Memo

Proposed amendments to the boundary of Rakaia-Selwyn Combined Surface and Groundwater Allocation Zone

Figure 1: the current boundary of the Rakaia-Selwyn Combined Surface and Groundwater Allocation Zone

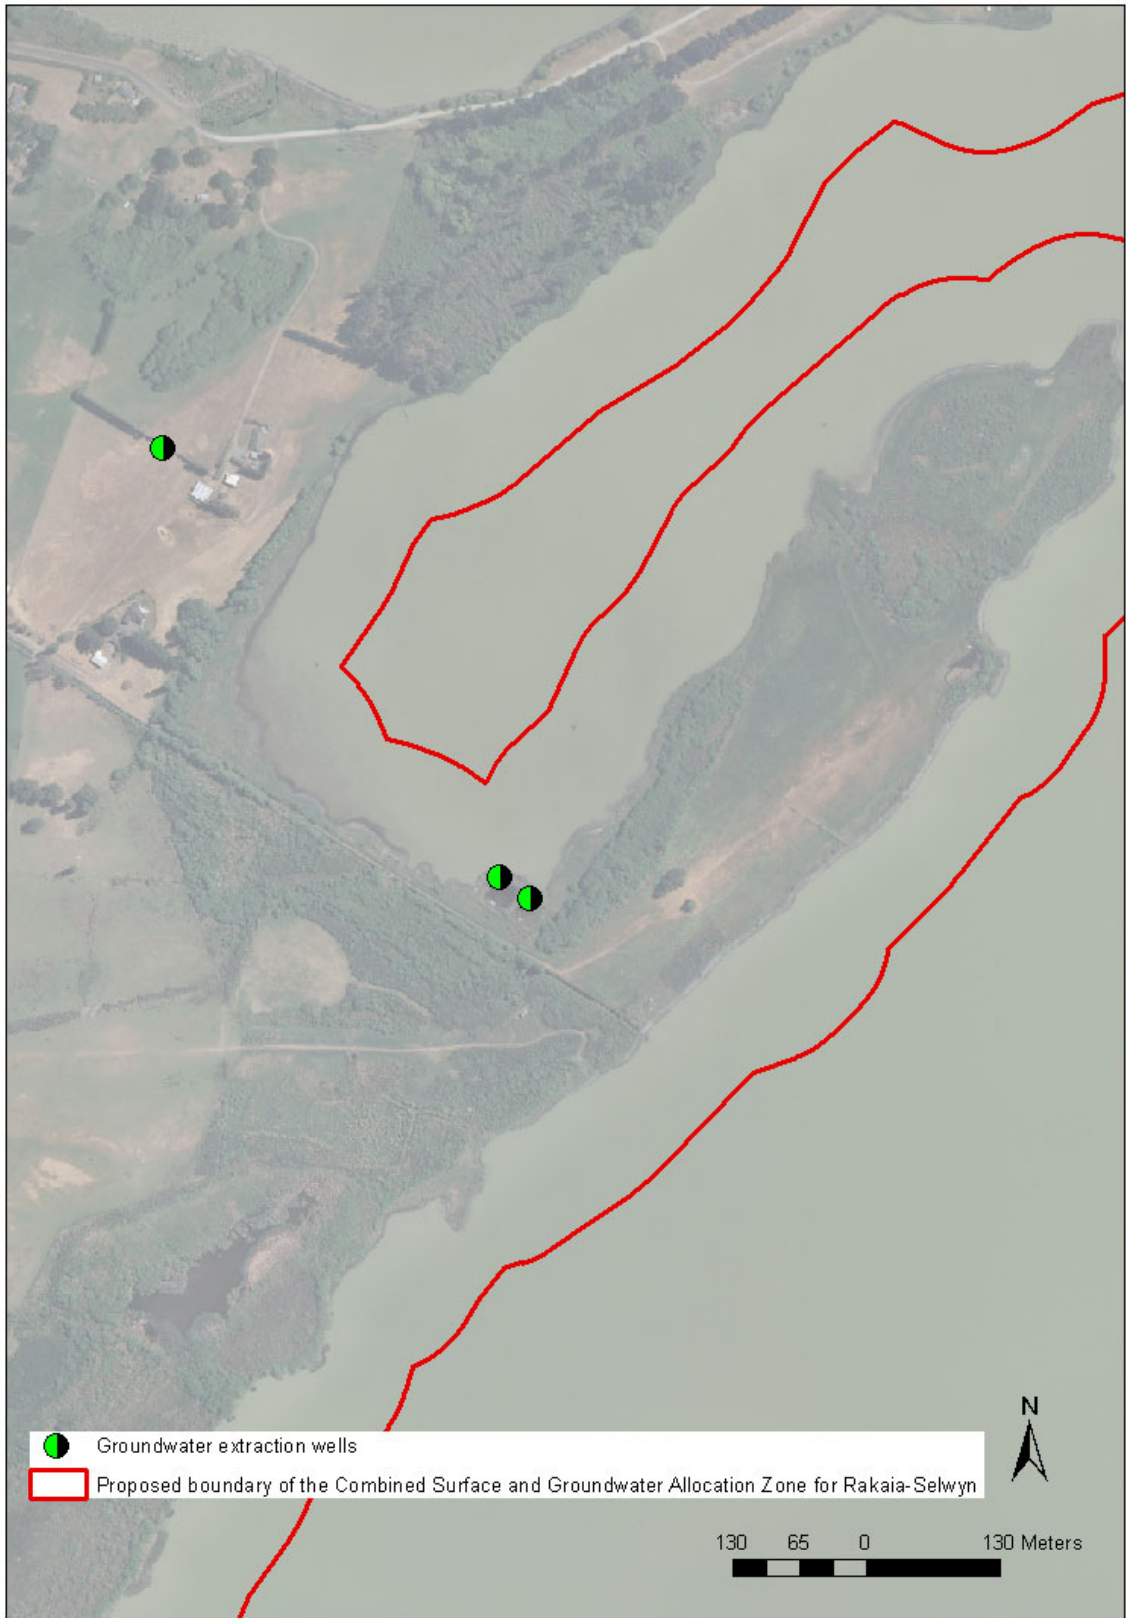
The boundary of the Combined Surface and Groundwater Allocation Zone for Rakaia-Selwyn as shown in the Land and Water Regional Plan (LWRP) Planning Maps (2014), finishes at approximately the edge of lake Te Waihora/Lake Ellesmere. The boundary however does not go precisely with the lake's edge. This leaves some wells located on the lake side out of any groundwater allocation zone. An example of this situation is presented in figure 1.

For the Omnibus Plan Change 2019, we recommend creating a 100m buffer inward from the lake shore to include any potential well that can be drilled there, as in figure 2.

The revisions to the LWRP Planning Maps will ensure that every well in this area belongs to an allocation zone.
